Preliminary Drainage Report – Early Grading Permit

# Waterview East Commercial El Paso County, Colorado

Project #: 196195000

PCD Filing No.: SP-22-009

**Basin ID: Pond 1**

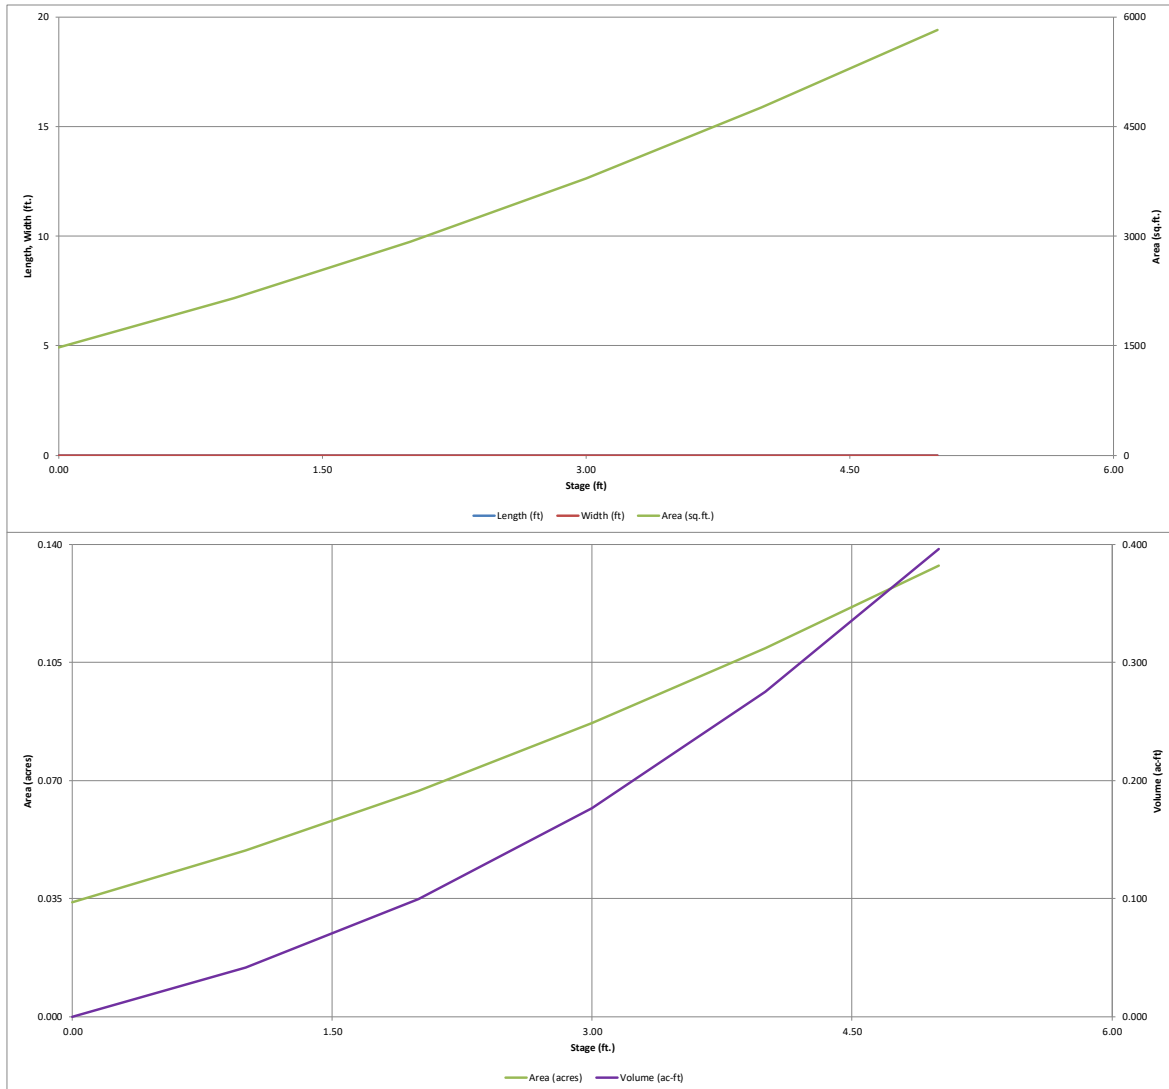
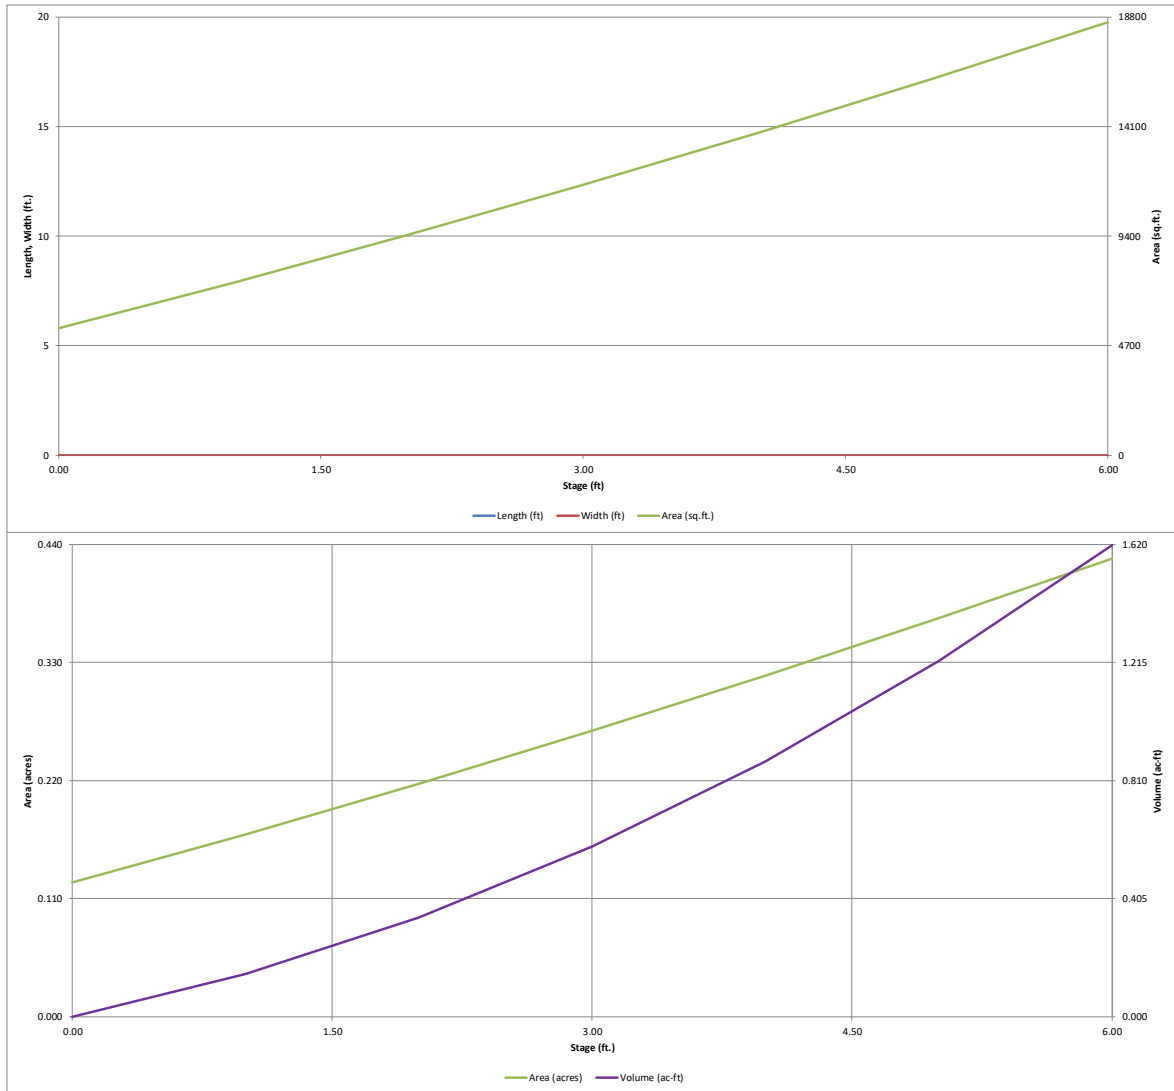
Please provide calculations for swales, which will direct flows through the site.

Please provide calculations for TSB ponds.

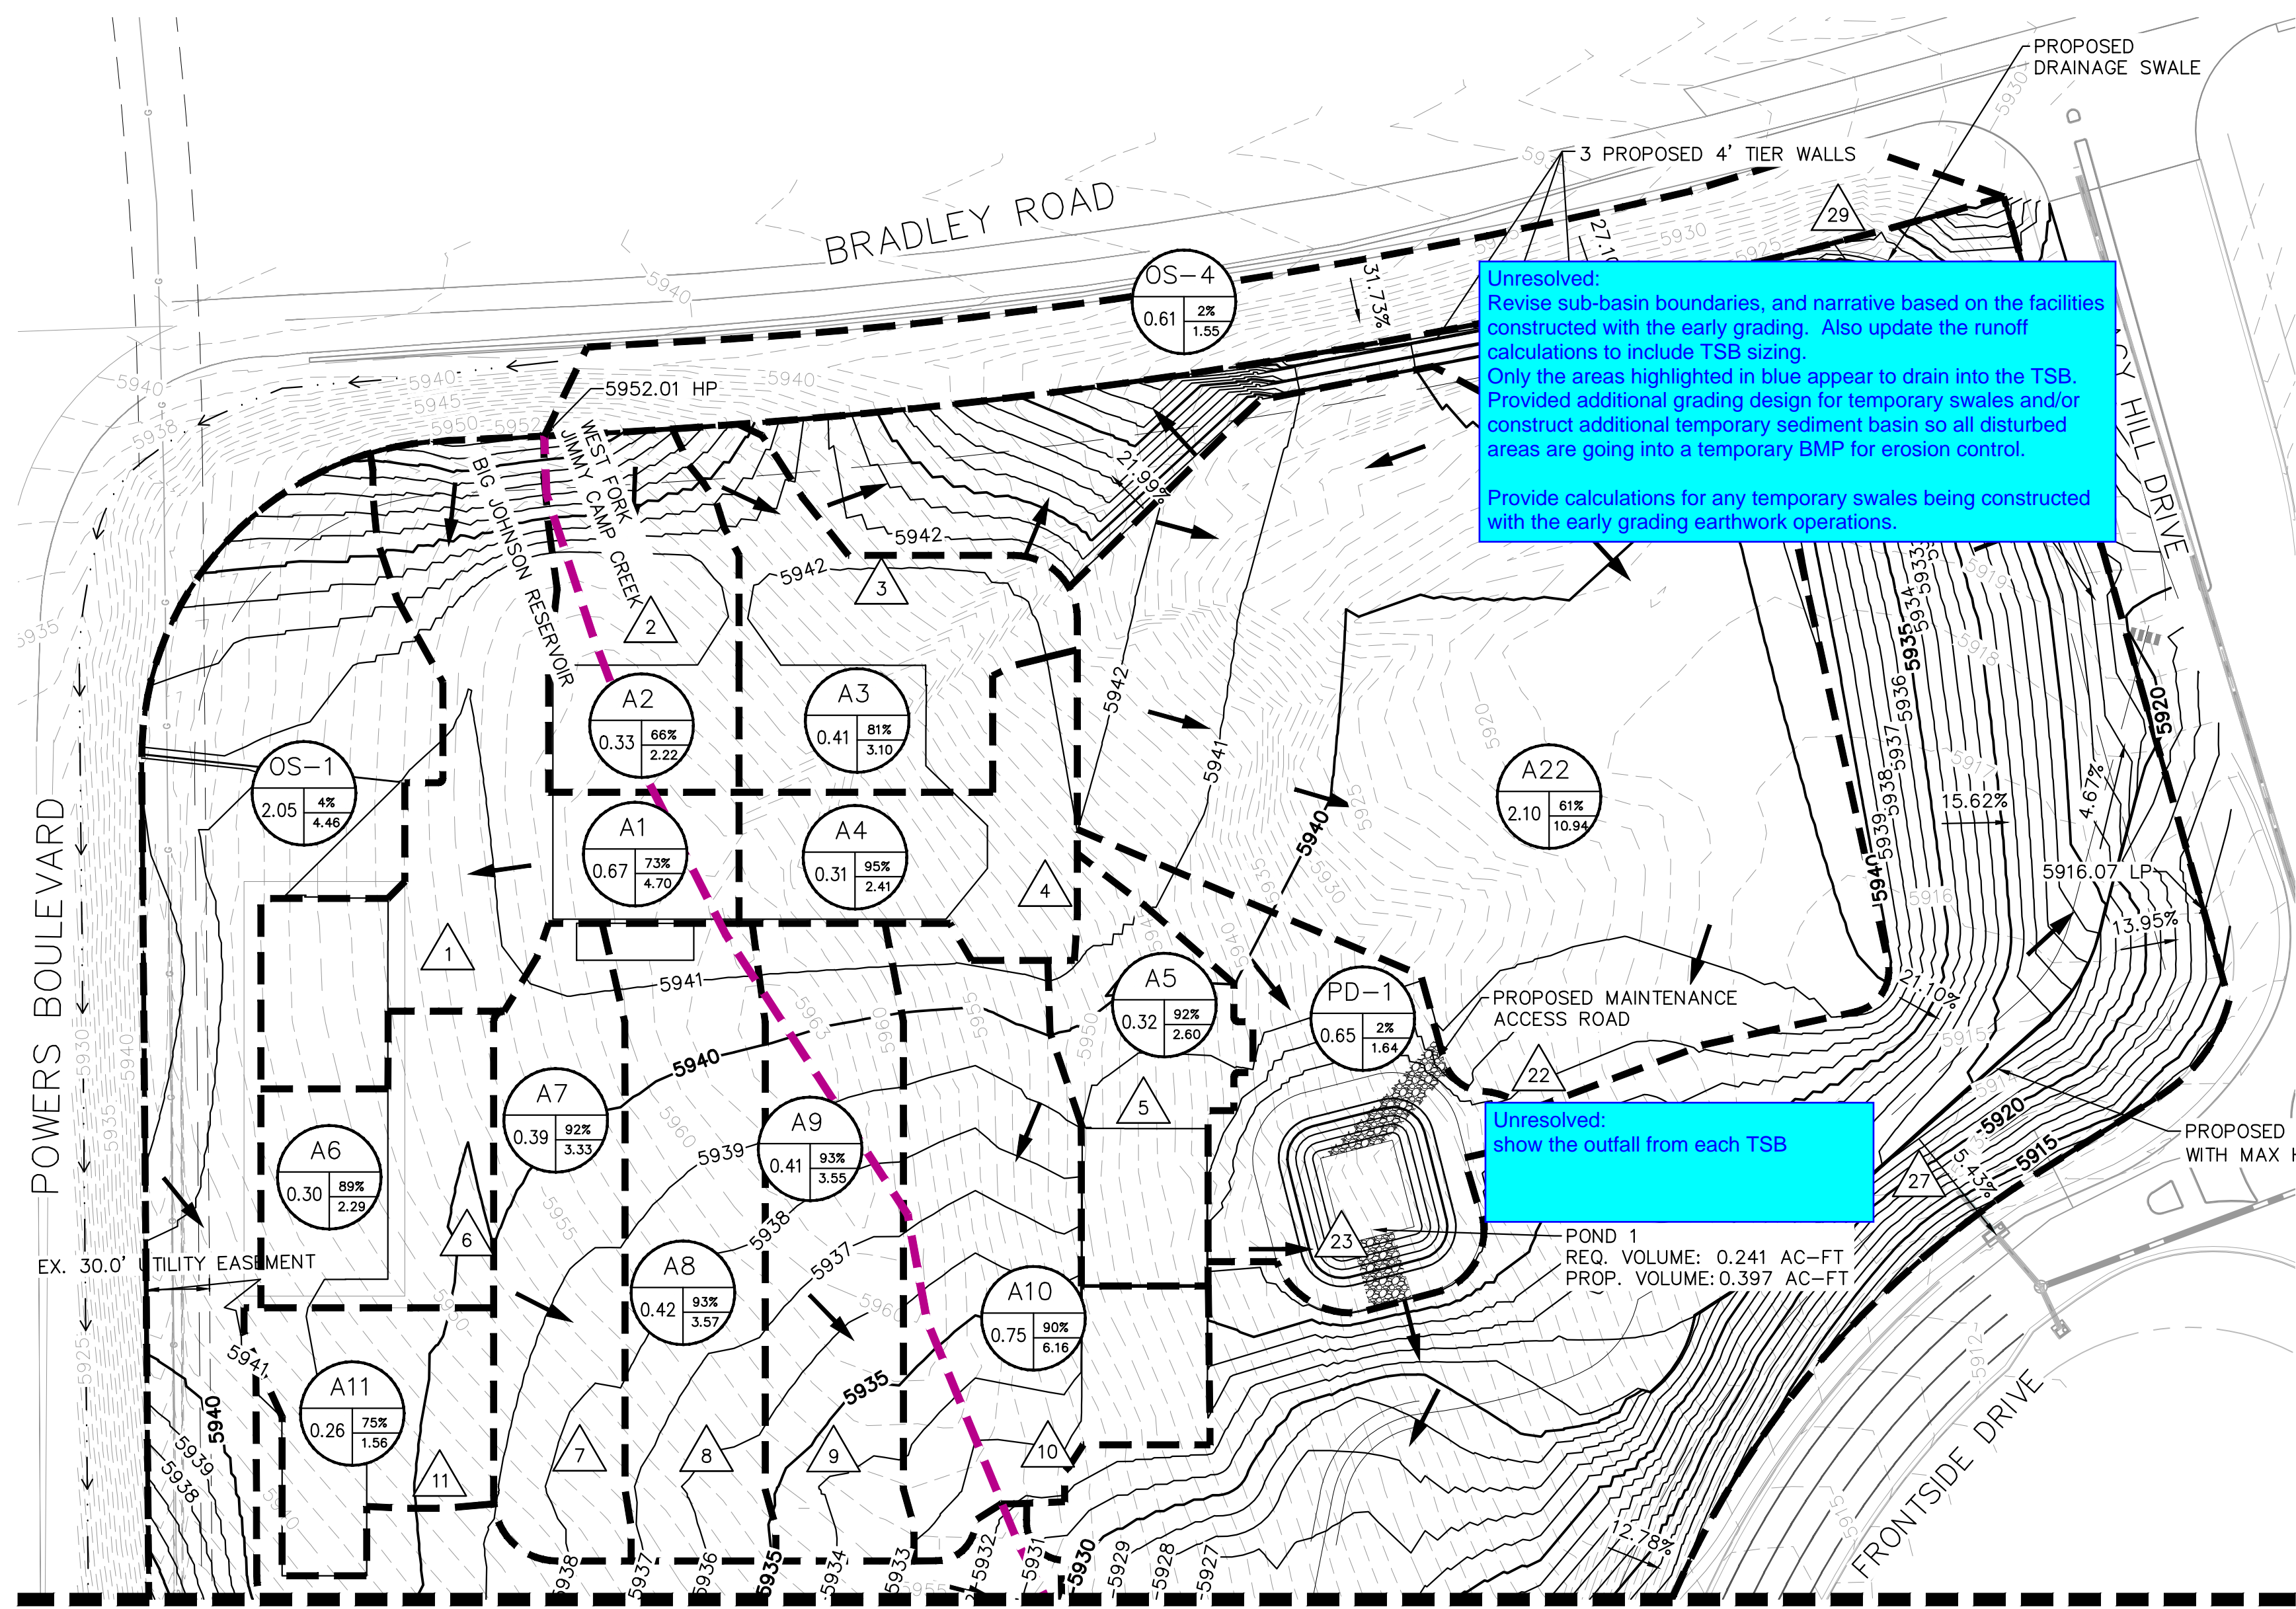
**Subject:** Text Box  
**Page Label:** [1] DR-EX  
**Author:** CDurham  
**Date:** 6/20/2023 5:23:18 PM  
**Status:**  
**Color:**   
**Layer:**  
**Space:** See comment on PDR for existing map.

DR-1

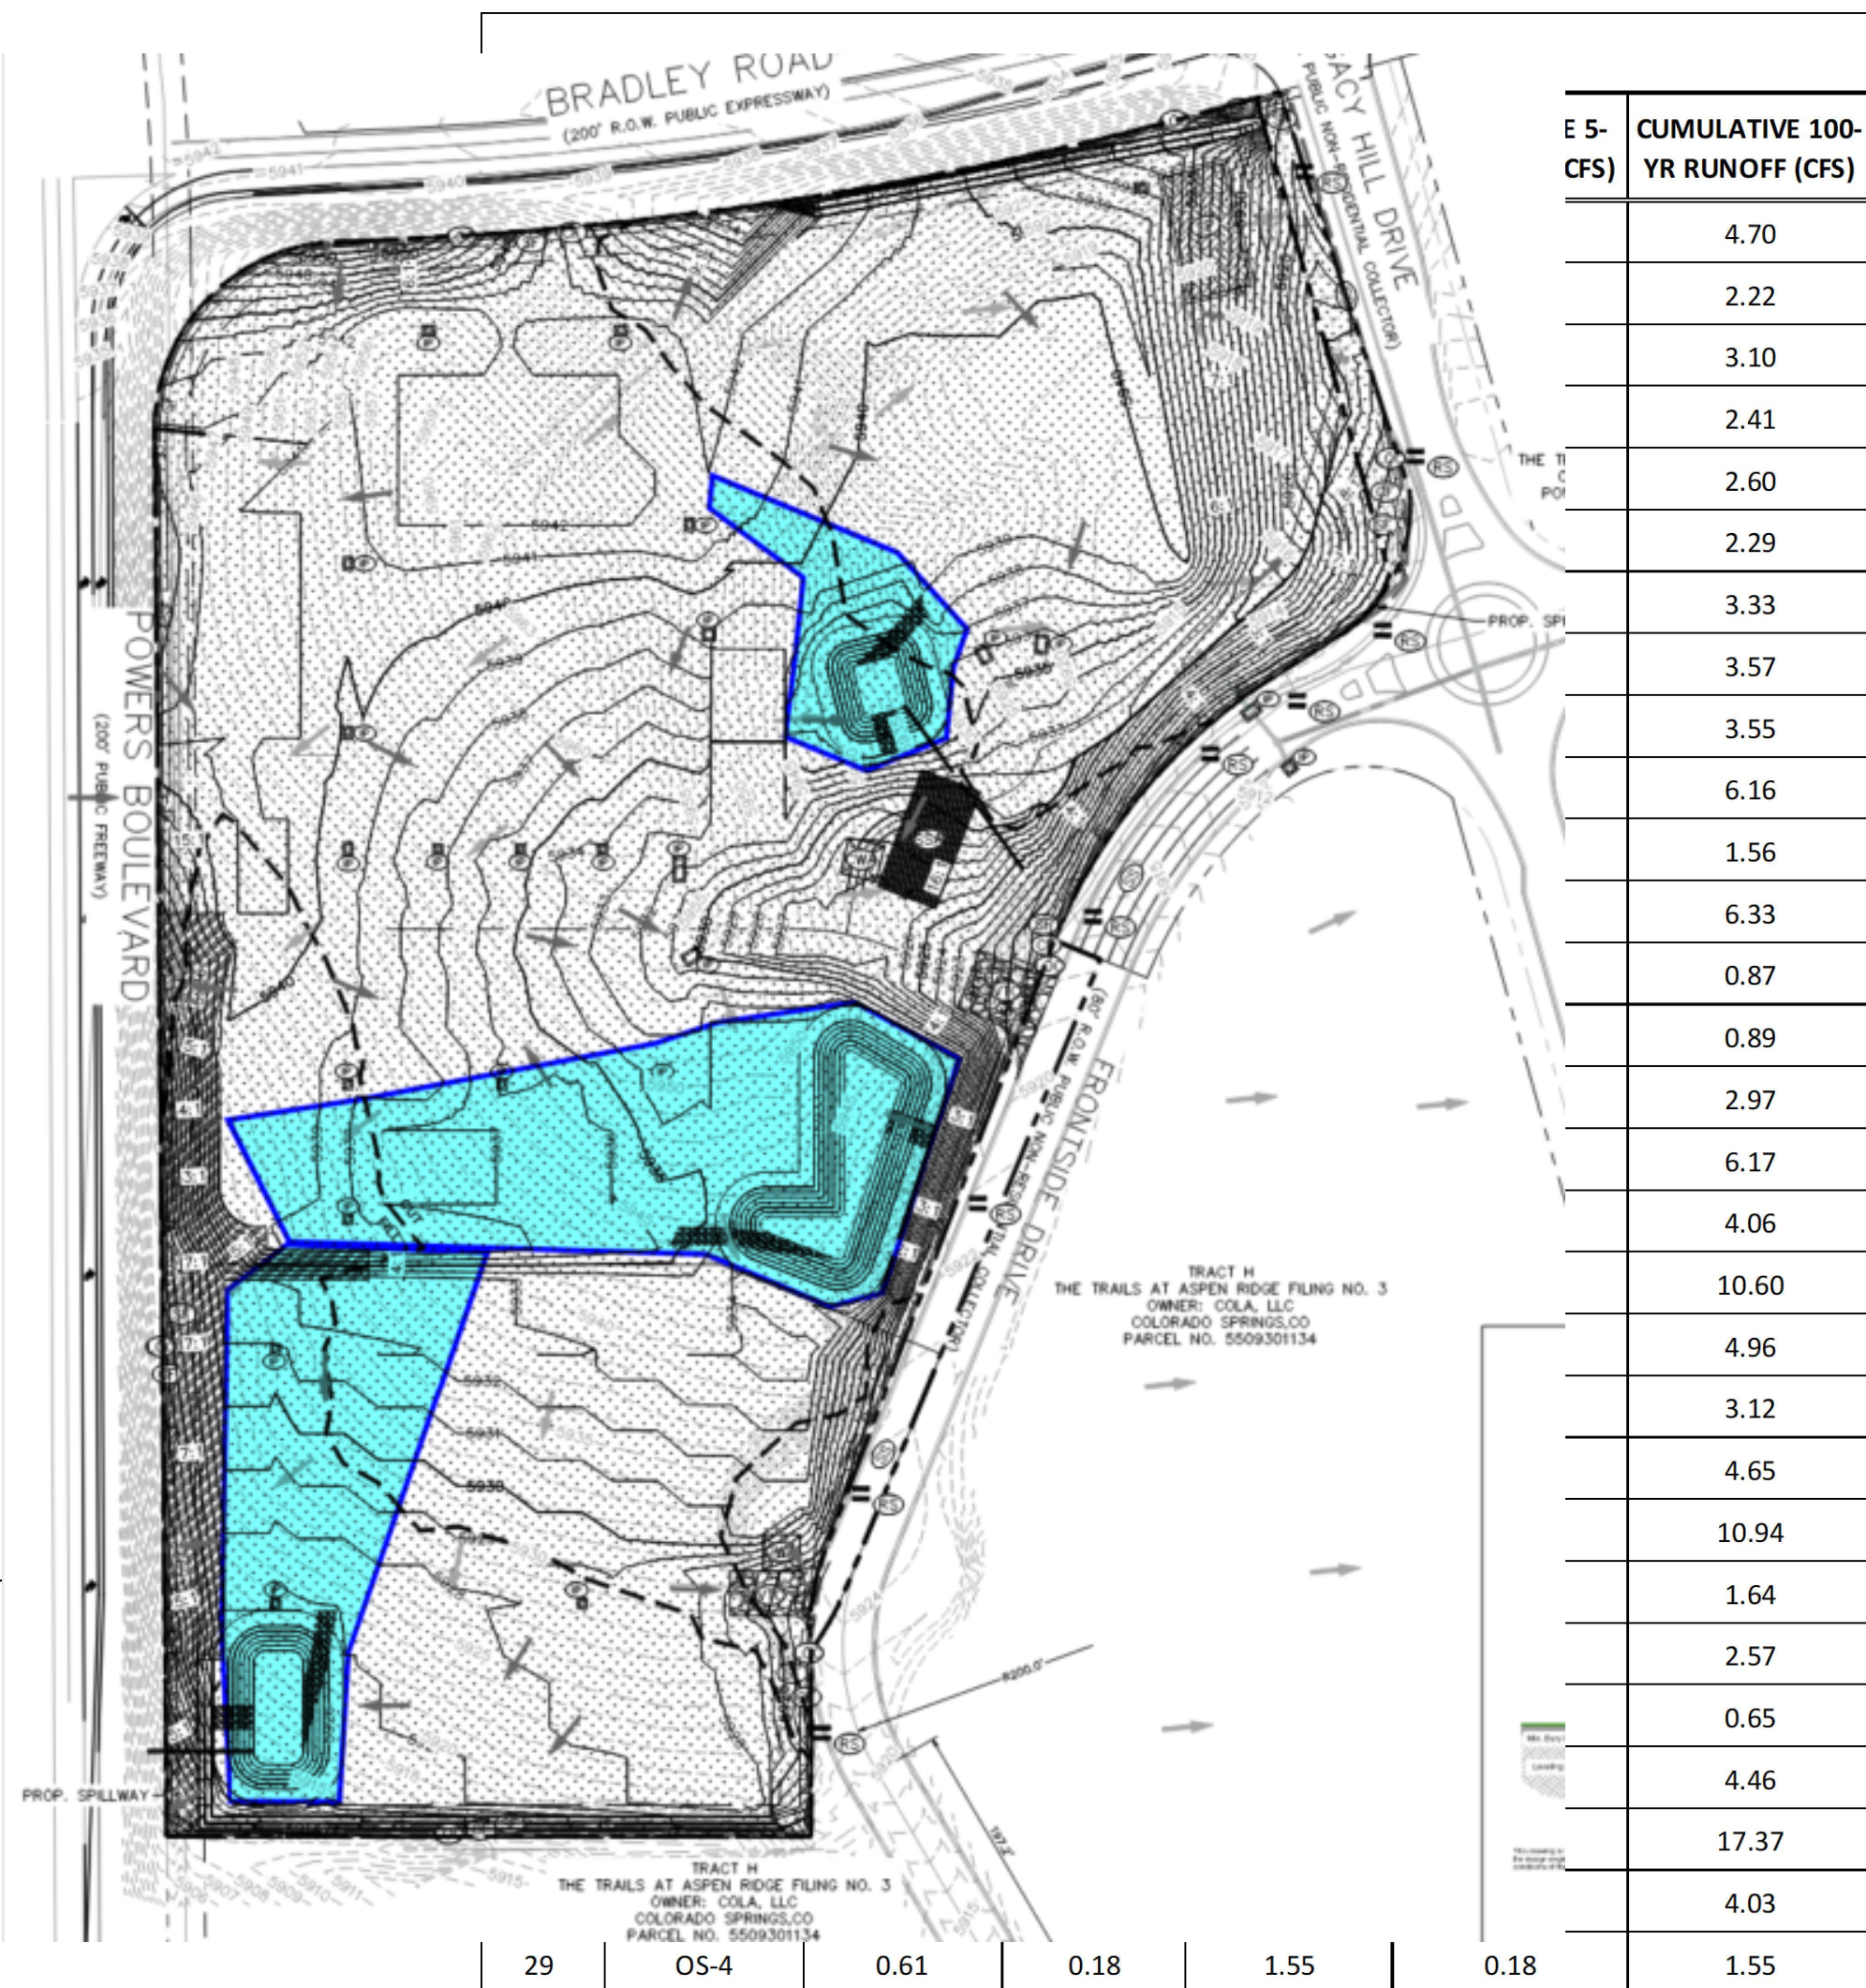
c&g, inlets, EDB's are not being built with early  
grading. Map should show how flows are moving  
across site with grading activities alone and no  
infrastructure being built.

Unresolved:  
show the outfall from each TSB

Unresolved:  
Revise sub-basin boundaries, and narrative based on the facilities constructed with the early grading. Also update the runoff calculations to include TSB sizing.  
Only the areas highlighted in blue appear to drain into the TSB. Provided additional grading design for temporary swales and/or construct additional temporary sediment basin so all disturbed areas are going into a temporary BMP for erosion control.

Provide calculations for any temporary swales being constructed with the early grading earthwork operations.
